SUBJECT: QUAD CITIES NUCLEAR POWER STATION, UNITS 1 AND 2- STAFF
ASSESSMENT OF RESPONSE TO 10 CFR 50.54(f) INFORMATION REQUEST
- FLOOD-CAUSING MECHANISM REEVALUATION (CAC NOS. MF1108 AND
MF1109)

STAFF ASSESSMENT BY THE OFFICE OF NUCLEAR REACTOR REGULATION
RELATED TO FLOODING HAZARD REEVALUATION REPORT
NEAR-TERM TASK FORCE RECOMMENDATION 2.1
QUAD CITIES NUCLEAR POWER STATION, UNITS 1 AND 2
DOCKET NOS. 50-254 AND 50-265

Figure 3.2-1. Probable Maximum Precipitation Distribution at Quad Cities Nuclear Power Station (1-h 1-mi²) (Exelon, 2015a)

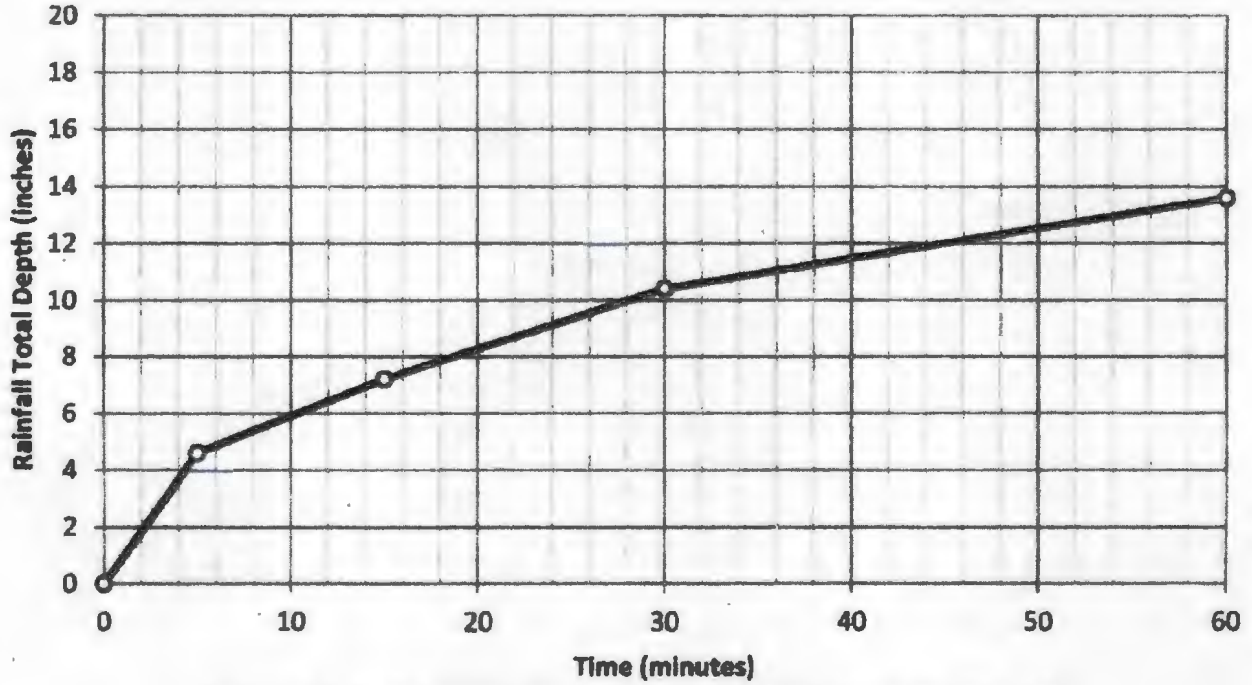
The NRC staff performed a separate sensitivity analysis on the temporal distribution of the rainfall (ORNL, 2015). The sub-hourly PMP depths for the 5-minute (min), 15-min, and 30-min time intervals were calculated by the licensee using ratios obtained from Figures 36, 37, and 38 of HMR 52 (Exelon, 2015a; NOAA, 1982). The rainfall hyetograph was arranged by the licensee using a front-loaded distribution, with the highest rainfall intensity occurring at the event onset (Exelon, 2015a). The licensee stated that the type of storm indicative of an LIP event would likely be a mesoscale convective system, which is associated with a zone of convergence and very intense initial precipitation that would maintain "a decrease in the precipitation after the initial burst as the rear trailing stratiform region with the cold pool moves over the area," thus fitting with a front loaded distribution (Exelon, 2014b). While this statement is true for some historical LIP-scale storms, alternative rainfall distributions have also frequently occurred. The

NRC staff's sensitivity analysis changed the rainfall distribution in the hydraulic model (FLO-2D) to a center weighted temporal distribution, as shown in Figure 3.2-1, and then computed the maximum water surface elevation at various locations around the site (ORNL, 2015). As expected, the results of this sensitivity study did increase the water depths around the site. However, the increases in water depths were small, with differences of 1.1 to 3.4 in. (2.7 to 8.6 cm) of the licensee's results (ORNL, 2015). Therefore, the NRC staff concluded that the licensee's temporal distribution of the ssPMP values is reasonable input to the hydraulic model and site drainage analysis discussed below.
